Procurement Department
IFB: Renovate Surge Spaces in Nature Science Building Phase 1
SU-042126
Addendum #2 * April 17, 2026

Purchase College Project #SU-042126
Renovate Surge Spaces in Natural Science Building – Phase 1

Addendum #02 – Telecomm & Audio Visual Infrastructure

Natural Science Building - 1st Floor Telecommunications and Audio Visual Infrastructure Plan

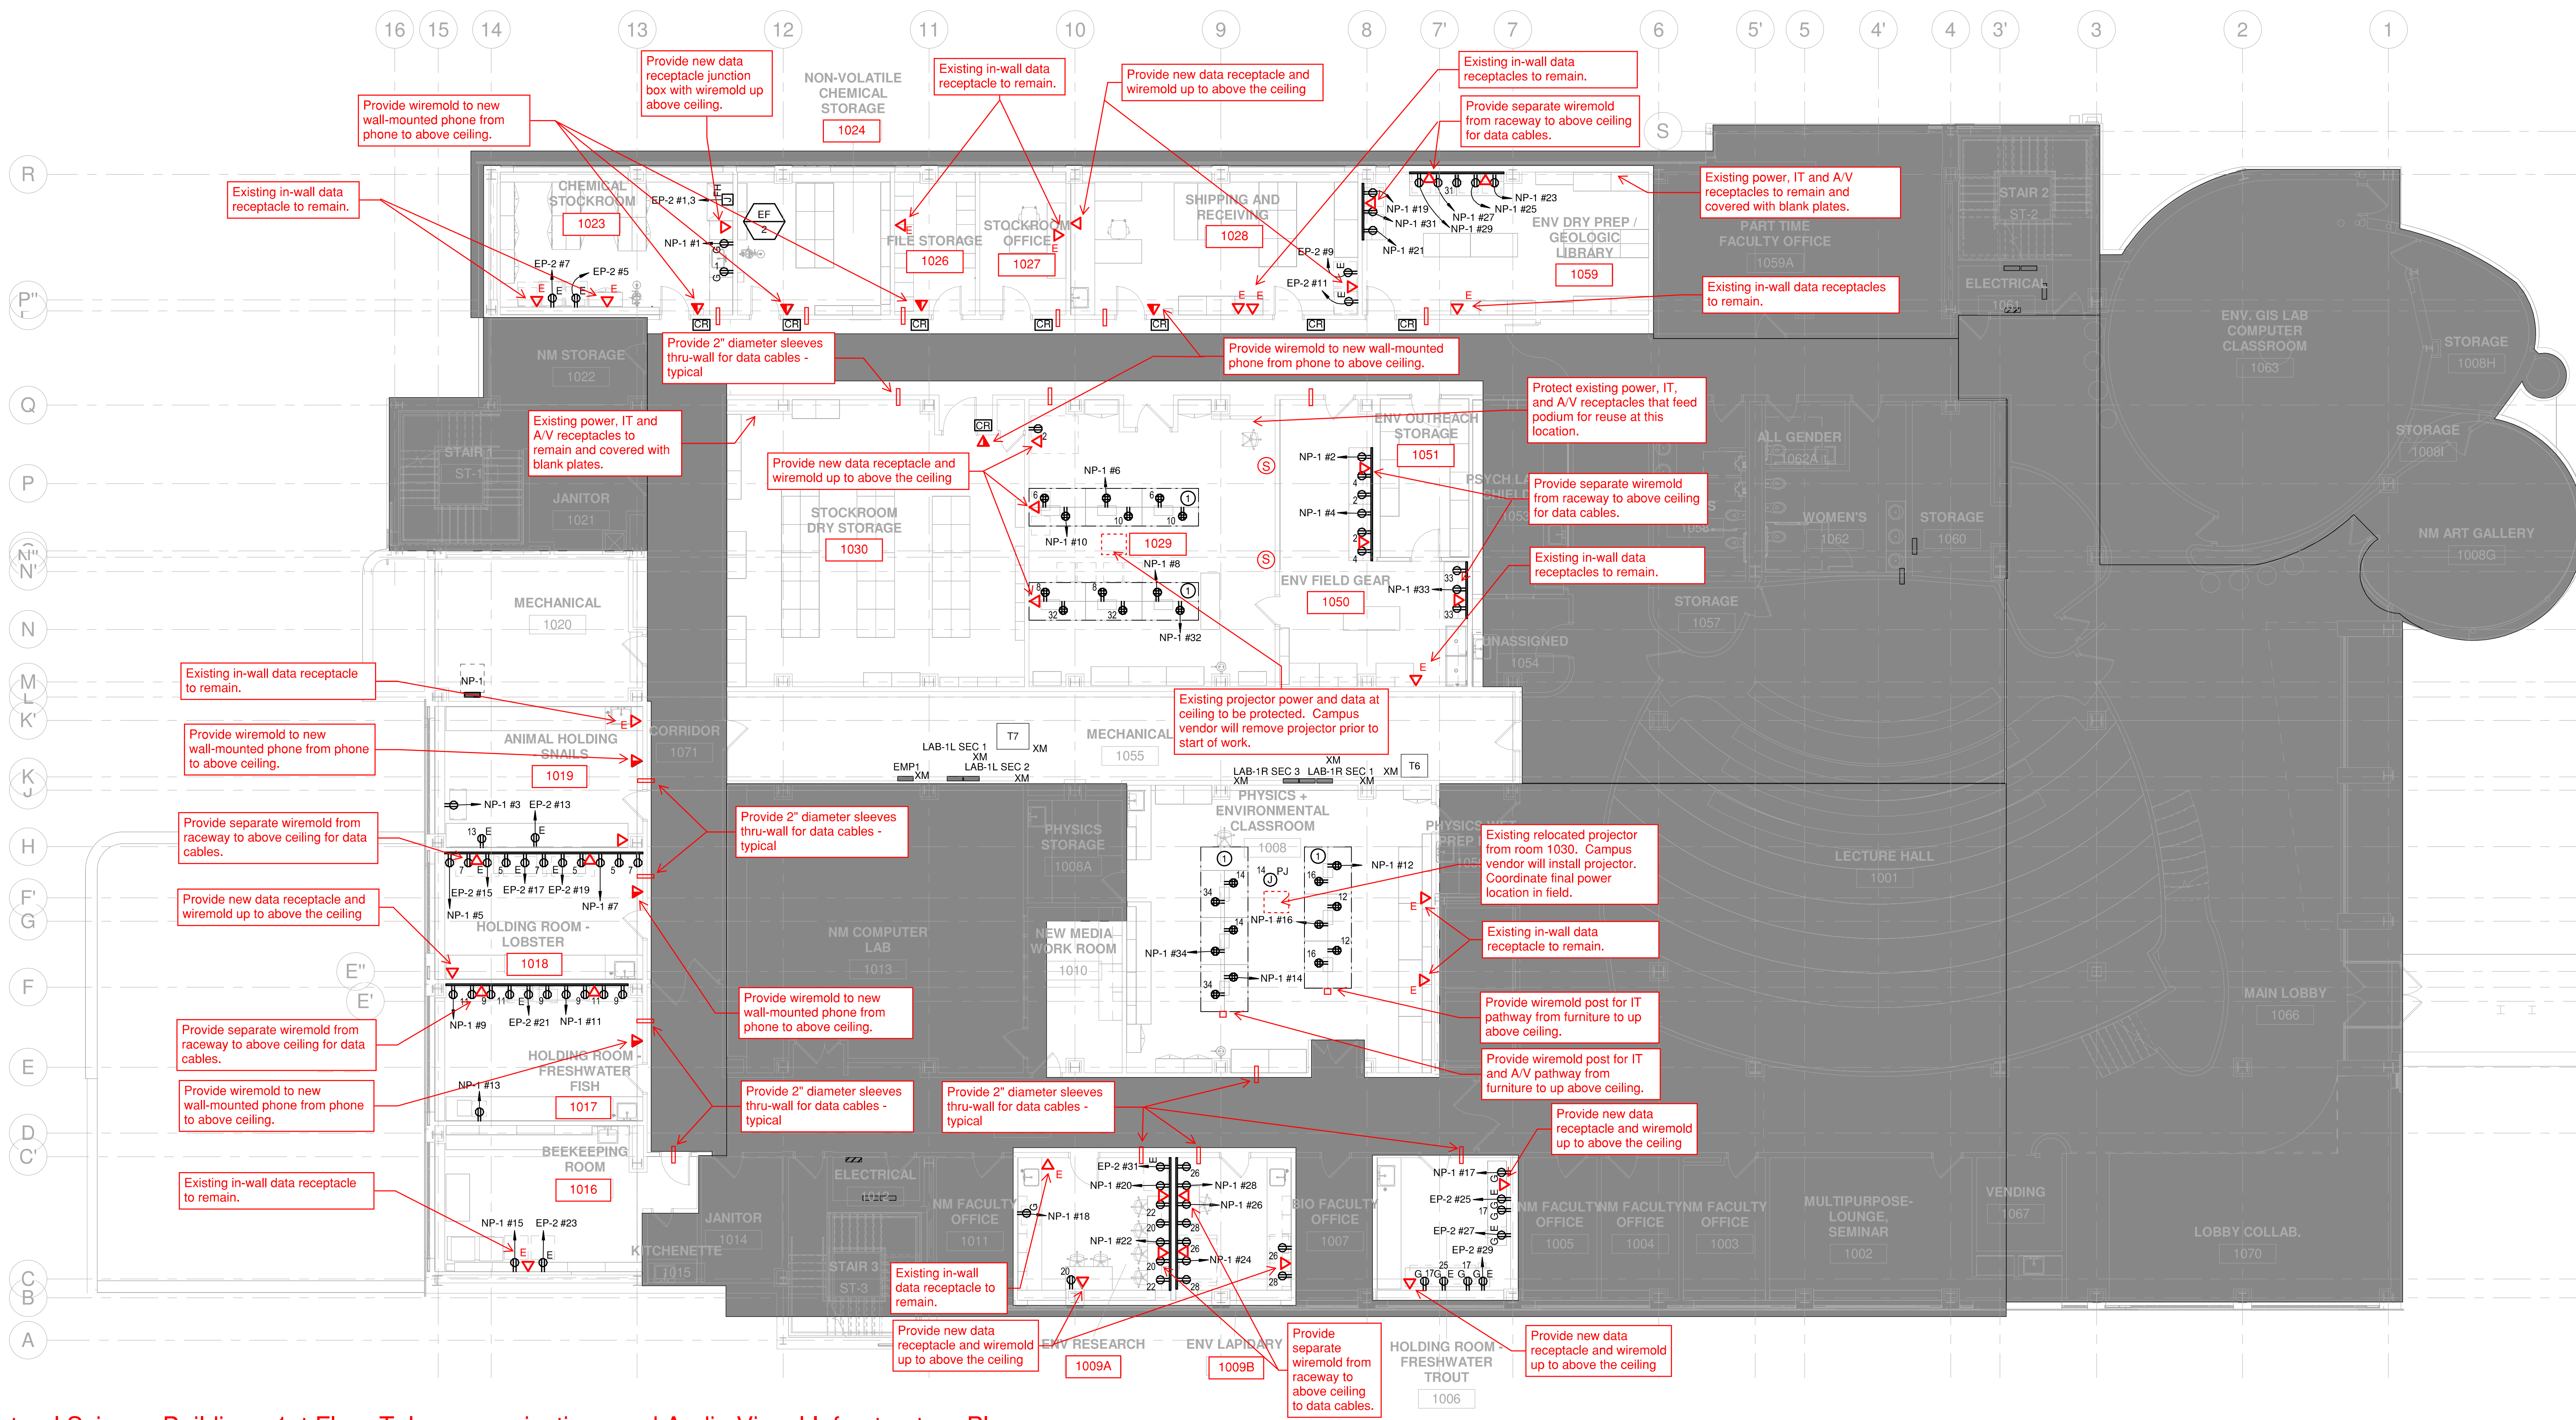
1st Floor

Room #1006

- Provide data junction box and wiremold or EMT stub-up to above ceiling on west and south walls as indicated.
- Provide 2" diameter sleeve in east wall above finished ceiling of adjoining corridor to allow IT cabling to feed into corridor ceiling.

Room #1008

- Existing in-wall data receptacles on south wall to remain.
- Provide wiremold vertical raceway for data and audio-visual cables from west end of presentation tables up above ceiling.
- Provide wiremold vertical raceway for data cables from west end of presentation tables up above ceiling.
- Provide 2" diameter sleeve in west wall above finished ceiling of adjoining corridor to allow IT cabling to feed into corridor ceiling.
- Coordinate final ceiling power location for relocated projector with campus A/V vendor.

Room #1009A

- Existing in-wall data receptacle on east wall to remain.
- Provide data junction box and wiremold or EMT stub-up to above ceiling on west wall as indicated.
- Provide 2" diameter sleeve in east wall above finished ceiling of adjoining corridor to allow IT cabling to feed into corridor ceiling.
- Provide IT cable pathway for Wiremold 4000 raceway on south wall up above ceiling.

Room #1009B

- Provide IT cable pathway for Wiremold 4000 raceway on north wall up above ceiling.
- Provide 2" diameter sleeve in east wall above finished ceiling of adjoining corridor to allow IT cabling to feed into corridor ceiling.
- Provide data junction box and wiremold or EMT stub-up to above ceiling on south wall as indicated.

Room #1016

- Existing in-wall data receptacle on west wall to remain.
- Provide 2" diameter sleeve in east wall above finished ceiling of adjoining corridor to allow IT cabling to feed into corridor ceiling.

Room #1017

- Provide IT cable pathway for Wiremold 4000 raceway on east wall up above ceiling.
- Provide 2" diameter sleeve in south wall above finished ceiling of adjoining corridor to allow IT cabling to feed into corridor ceiling.
- Provide data junction box and wiremold or EMT stub-up to above ceiling on south wall as indicated for wall phone.

Room #1018

- Provide IT cable pathway for Wiremold 4000 raceway on east wall up above ceiling.
- Provide data junction box and wiremold or EMT stub-up to above ceiling on west wall as indicated. Receptacle will be located above counter.

- Provide 2” diameter sleeve in south wall above finished ceiling of adjoining corridor to allow IT cabling to feed into corridor ceiling.
- Provide data junction box and wiremold or EMT stub-up to above ceiling on south wall as indicated for wall phone.

Room #1019

- Existing data receptacle in southeast corner of room to remain.
- Provide 2” diameter sleeve in south wall above finished ceiling of adjoining corridor to allow IT cabling to feed into corridor ceiling.
- Provide data junction box and wiremold or EMT stub-up to above ceiling on south wall as indicated for wall phone.
- Provide data junction box and wiremold or EMT stub-up to above ceiling on west wall as indicated. Receptacle will be located above counter.

Room #1023

- Existing data receptacles on west wall of room to remain.
- Provide 2” diameter sleeve in west wall above finished ceiling of adjoining corridor to allow IT cabling to feed into corridor ceiling.
- Provide data junction box and wiremold or EMT stub-up to above ceiling on west wall as indicated for wall phone.
- Provide data junction box and wiremold or EMT stub-up to above ceiling on south wall as indicated.

Room #1024

- Provide 2” diameter sleeve in west wall above finished ceiling of adjoining corridor to allow IT cabling to feed into corridor ceiling.
- Provide data junction box and wiremold or EMT stub-up to above ceiling on west wall as indicated for wall phone.

Room #1026

- Existing data receptacles on north wall of room to remain.
- Provide 2” diameter sleeve in west wall above finished ceiling of adjoining corridor to allow IT cabling to feed into corridor ceiling.
- Provide data junction box and wiremold or EMT stub-up to above ceiling on west wall as indicated for wall phone.

Room #1027

- Existing data receptacles on south wall of room to remain.
- Provide 2” diameter sleeve in west wall above finished ceiling of adjoining corridor to allow IT cabling to feed into corridor ceiling.

Room #1028

- Provide data junction box and wiremold or EMT stub-up to above ceiling on both north and south walls as indicated.
- Provide 2” diameter sleeve in west wall above finished ceiling of adjoining corridor to allow IT cabling to feed into corridor ceiling.
- Provide data junction box and wiremold or EMT stub-up to above ceiling on west wall as indicated for wall phone.
- Existing data receptacles on west wall of room to remain.

Room #1029

- Provide data junction boxes and wiremold or EMT stub-up to above ceiling on north wall as indicated.

- Provide 2" diameter sleeve in east wall above finished ceiling of adjoining corridor to allow IT cabling to feed into corridor ceiling.
- Existing power and A/V cables in ceiling for existing projector to be protected. Campus A/V contractor will temporarily remove existing projector prior to the start of work.
- Protect existing power, IT, and A/V feeds to existing podium in southeast corner of room. Campus A/V vendor will disconnect and remove existing podium for future reinstallation prior to the start of work.
- Protect existing speaker feeds on south wall. Campus A/V vendor will disconnect and remove existing speakers for future reinstallation prior to the start of work.

Room #1030

- Provide 2" diameter sleeve in east wall above finished ceiling of adjoining corridor to allow IT cabling to feed into corridor ceiling.
- Provide data junction box and wiremold or EMT stub-up to above ceiling on west wall as indicated for wall phone.
- Protect existing power, IT, and A/V feeds to existing podium in northeast corner of room. Campus A/V vendor will disconnect and remove existing podium prior to the start of work.

Room #1050

- Provide 2" diameter sleeve in east wall above finished ceiling of adjoining corridor to allow IT cabling to feed into corridor ceiling.
- Provide IT cable pathway for Wiremold 4000 raceway on south walls up above ceiling.
- Existing data receptacle on west wall of room to remain.

Room 1059

- Provide IT cable pathway for Wiremold 4000 raceway on north and east walls up above ceiling.
- Provide 2" diameter sleeve in east wall above finished ceiling of adjoining corridor to allow IT cabling to feed into corridor ceiling.
- Protect existing power, IT, and A/V feeds to existing podium in southeast corner of room. Campus A/V vendor will disconnect and remove existing podium prior to the start of work.
- Existing data receptacle on west wall of room to remain.
